SUBJECT: Reply to Request for Additional Information Regarding Final Status  
Survey Report

FINAL STATUS SURVEY PLAN: POWER PLANT MACHINE SHOP

**FIGURE C-1** REACTOR ROOM PLAN (1957 - 1960)  
(ORIGINAL LOCATION)

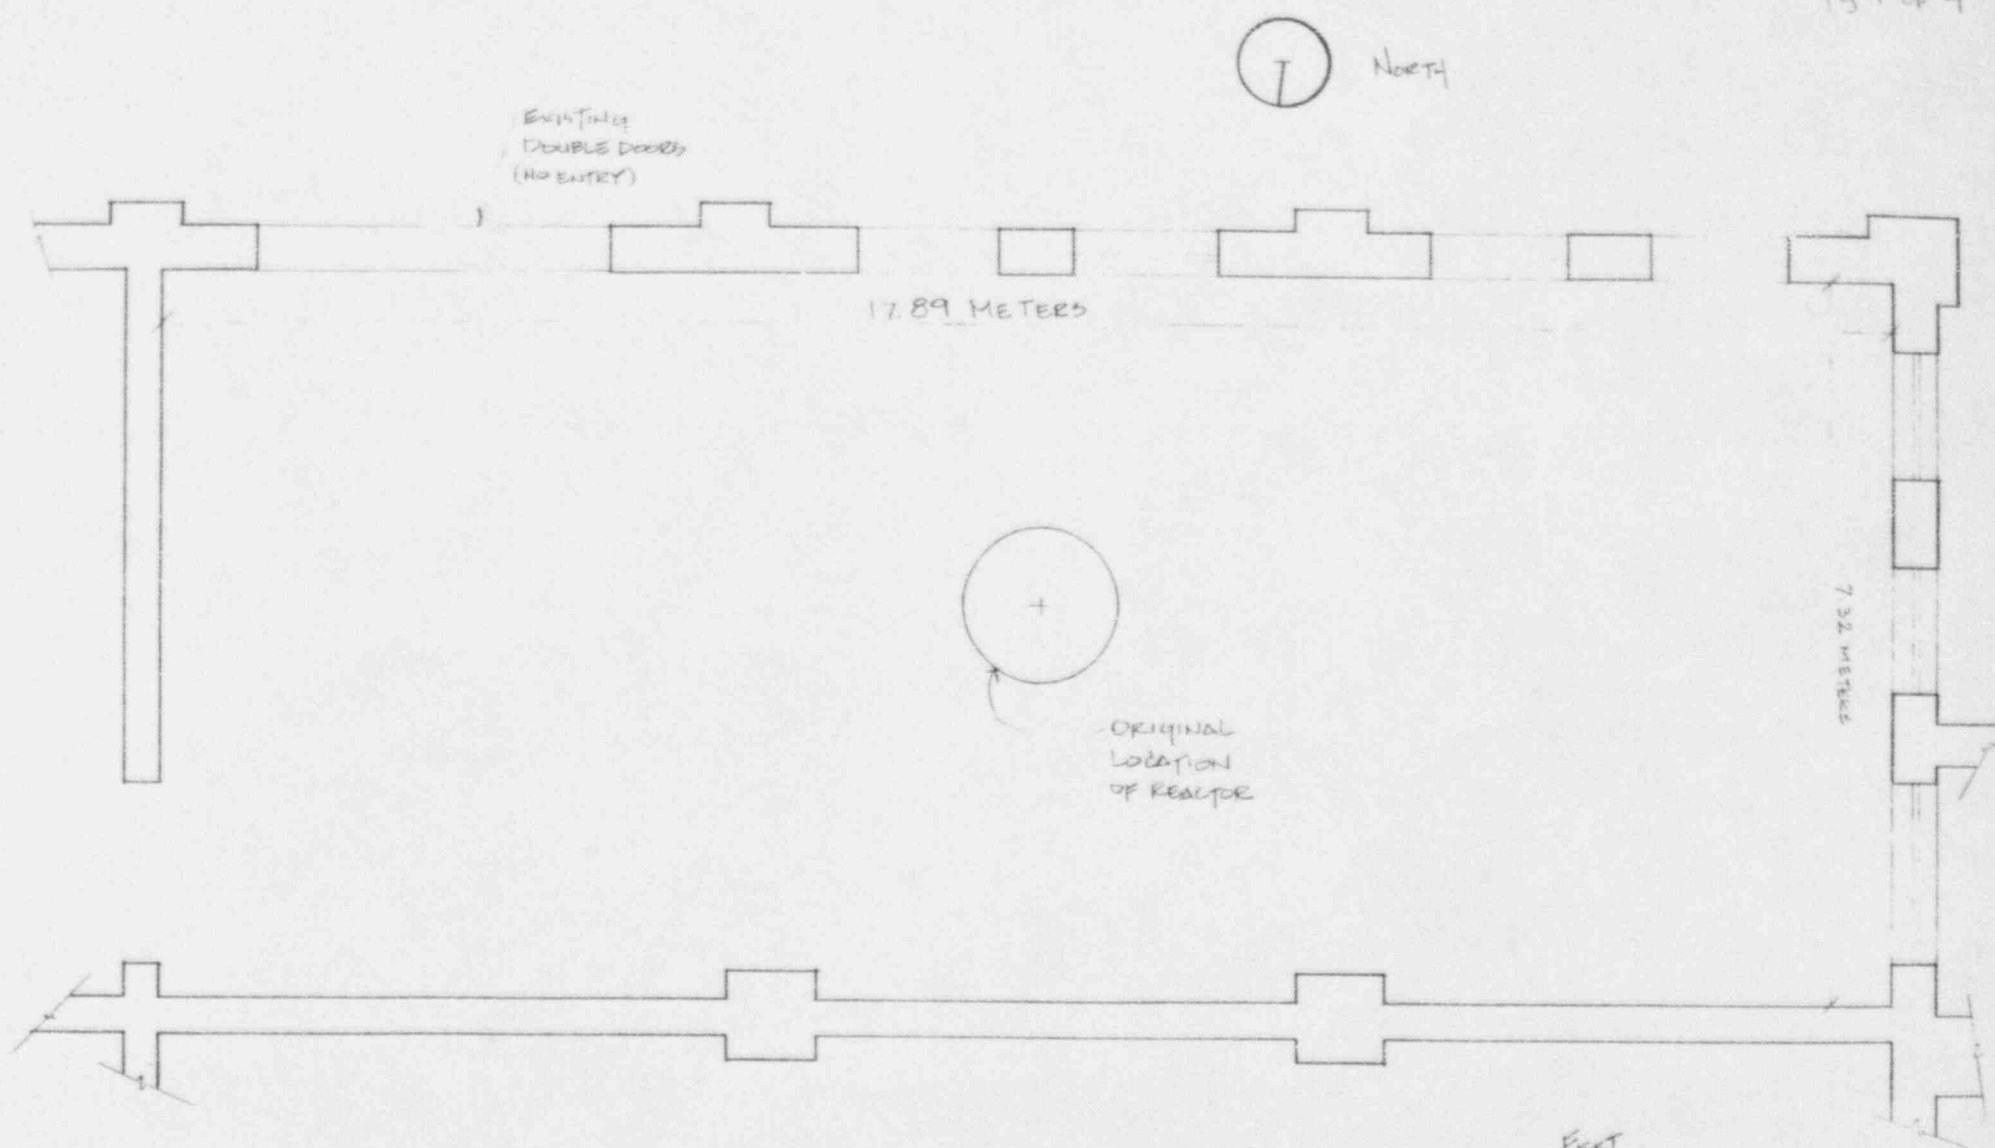
The approximate 24 ft. x 58 ft. rectangular room which originally housed the reactor was slightly modified in 1961 by the construction of an internal floor-to-ceiling cement block wall which partitioned off a triangular area used to house new boiler equipment. (See Figure C-1 and C-2.) The remainder of the room was converted into a machine shop and continues to function in this capacity.

**FIGURE C-3** **POWER PLANT - MACHINE SHOP**

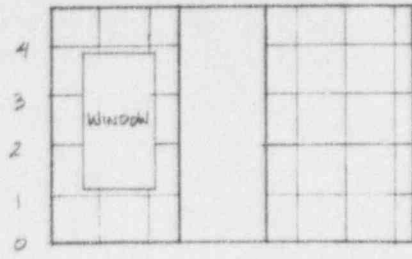
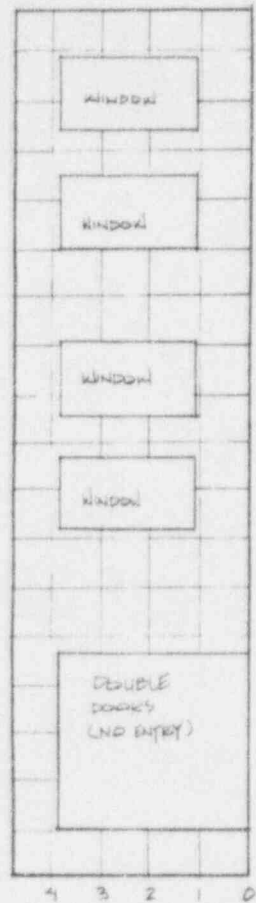
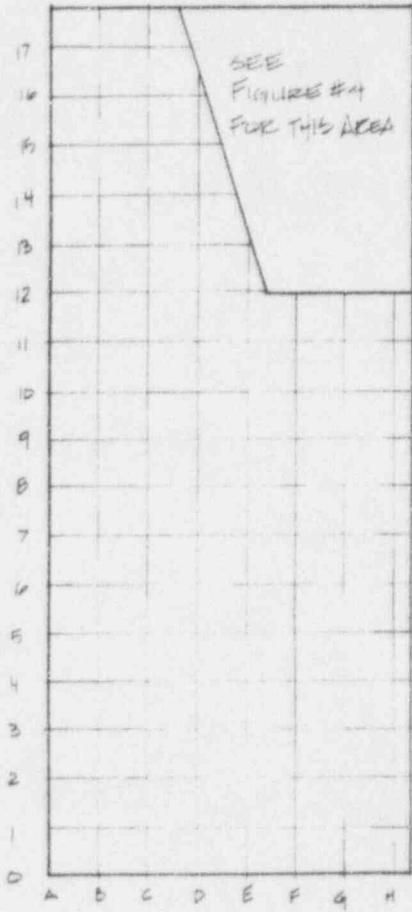
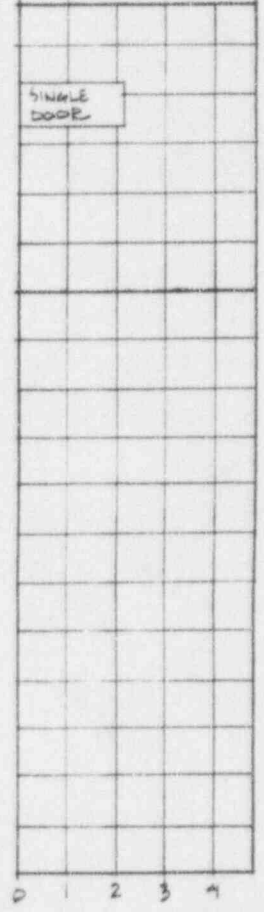
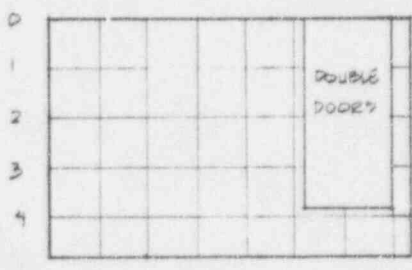
The room will be gridded, on a map only (Figures C-3 and C-4), into one meter square block. The "points" formed by the intersecting lines will be used as survey point locations as follows:

At least thirty wipe measurements of 100 cm<sup>2</sup> (nominal) will be taken on elevated horizontal surfaces within the rooms. Locations will be referenced to the floor grid map, Figures C-3 and C-4. At least thirty wipe measurements will be taken on the lower surfaces (floors and walls up to two meters.)
